## Advanced LIGO I & Q RF Demodulator (2 channel version)

DCC: [E1200113](#)

### Design document

The modifications for high bandwidth operations of the demodulator board D0902745-v4 can be found in [E1100044-v1](#):

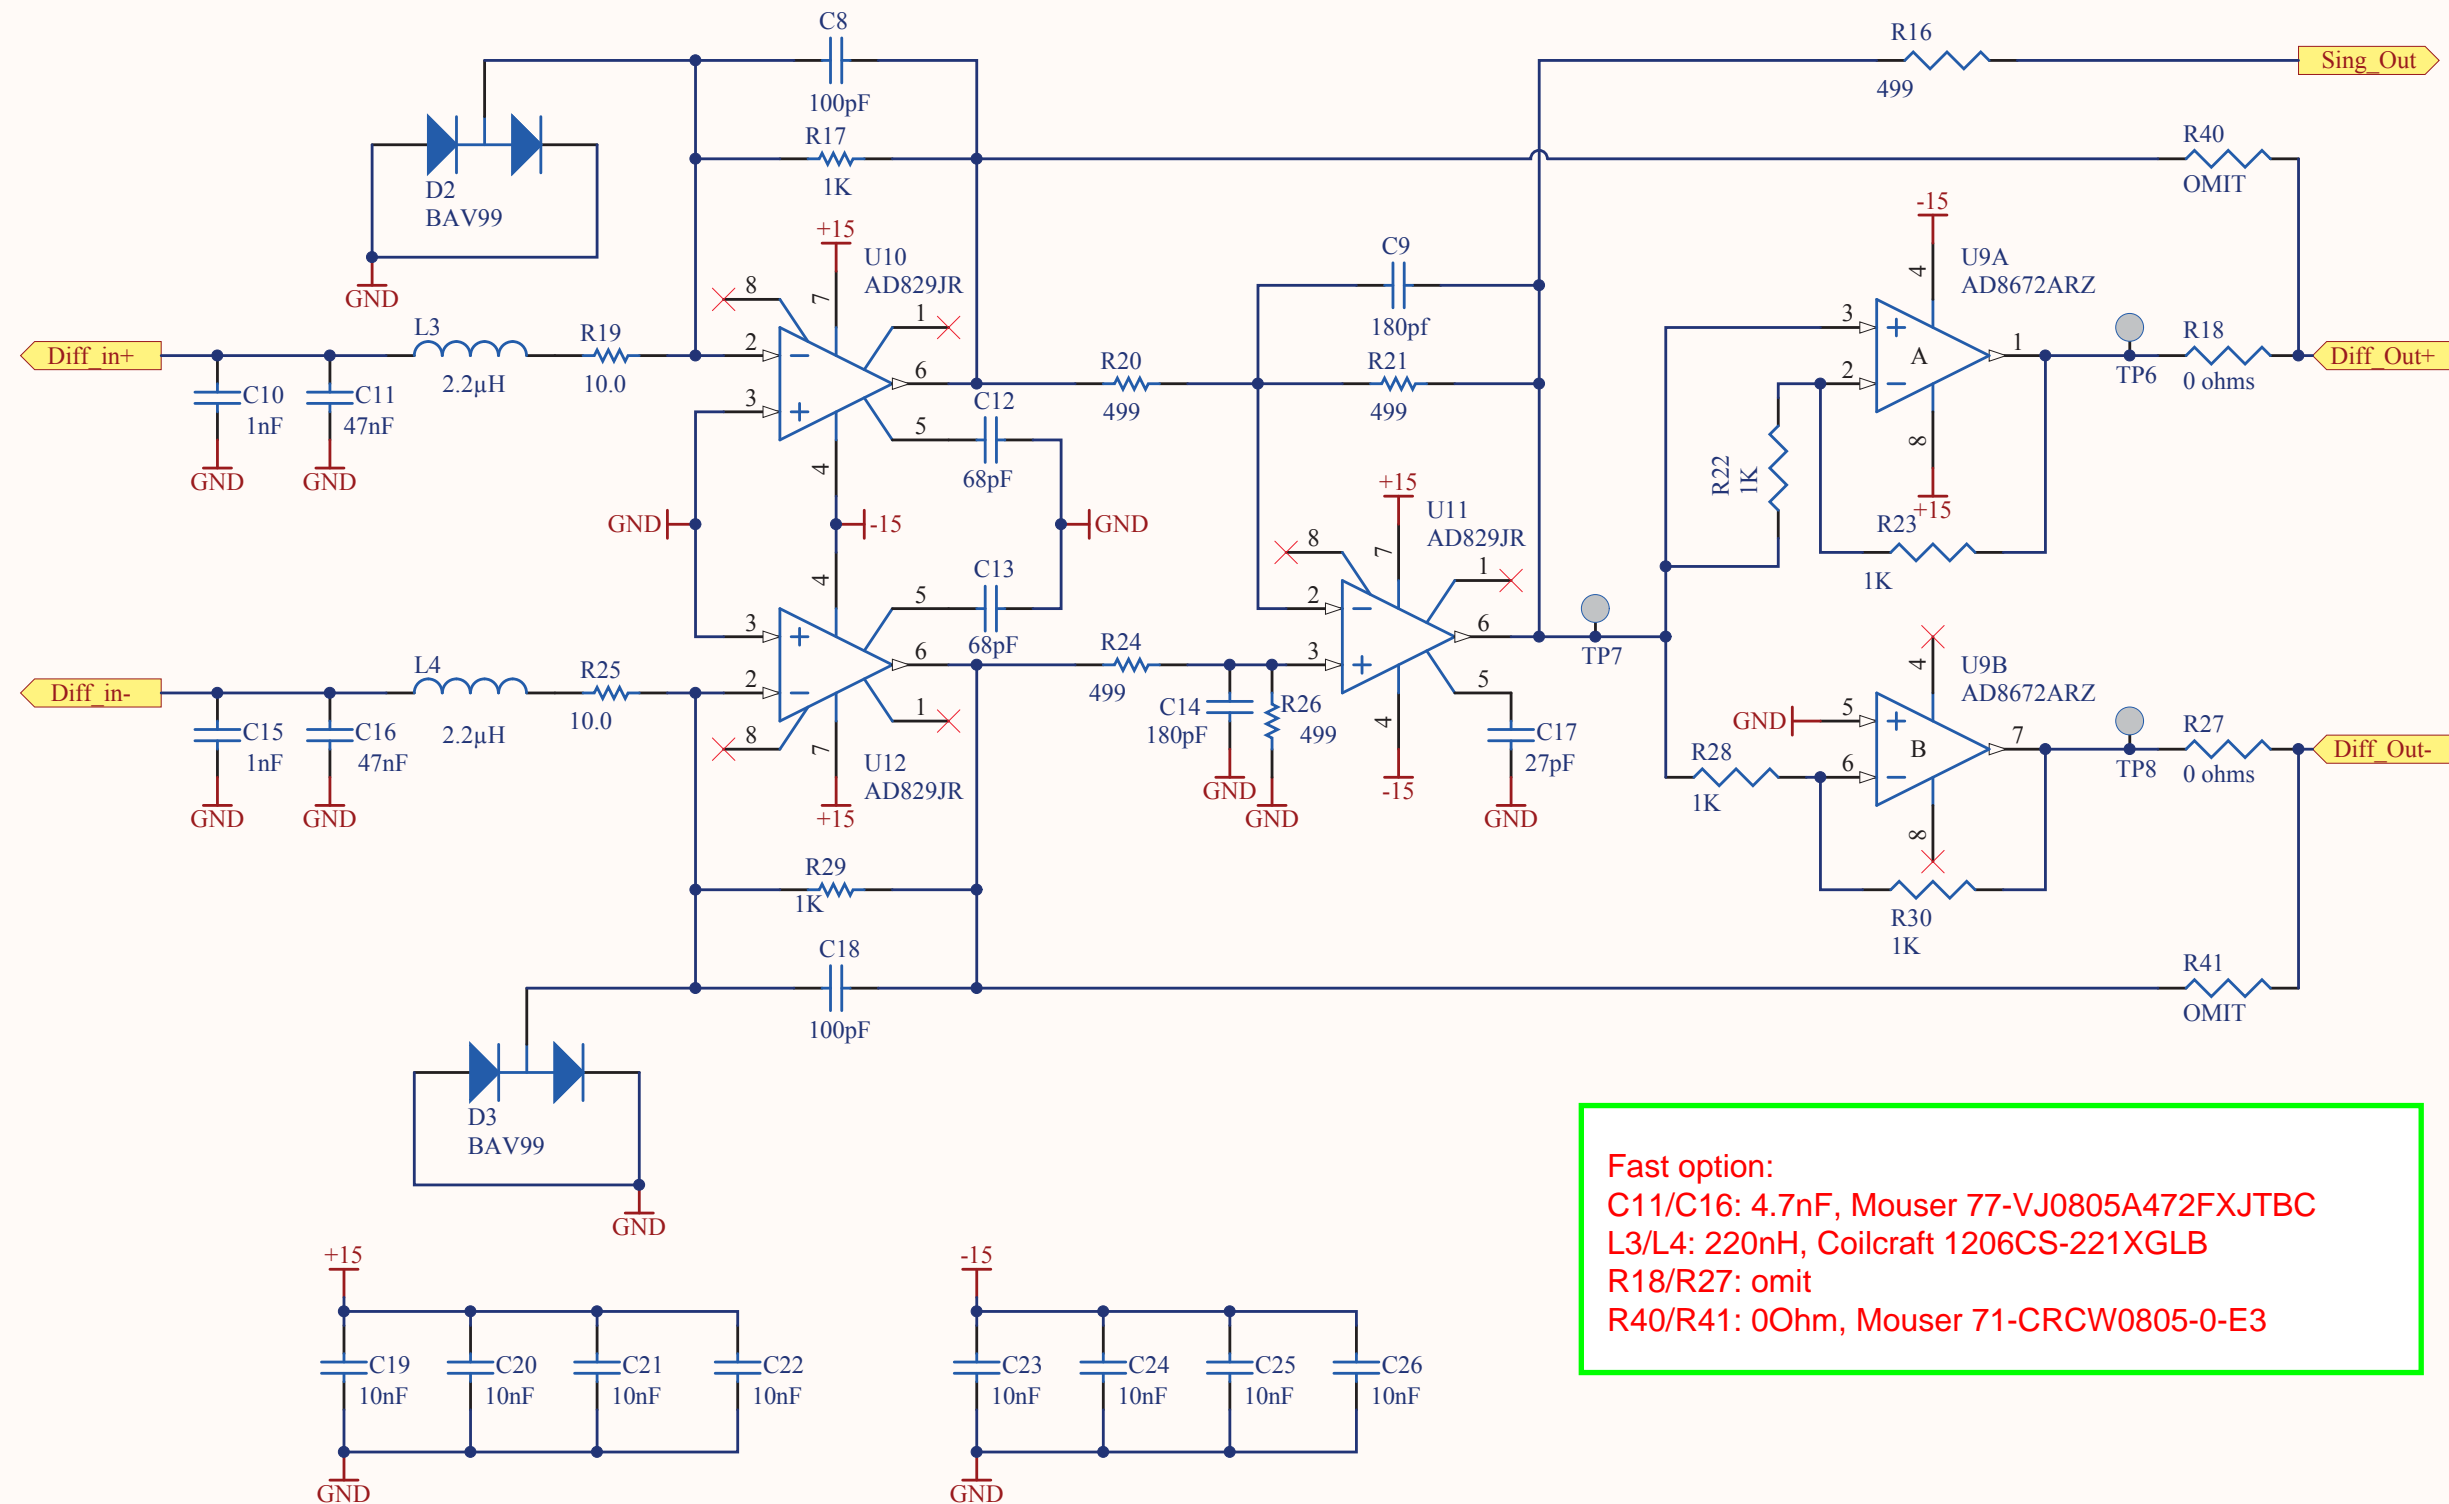
Fast option:  
 C11/C16: 4.7nF, Mouser 77-VJ0805A472FXJTBC  
 L3/L4: 220nH, Coilcraft 1206CS-221XGLB  
 R18/R27: omit  
 R40/R41: 0Ohm, Mouser 71-CRCW0805-0-E3
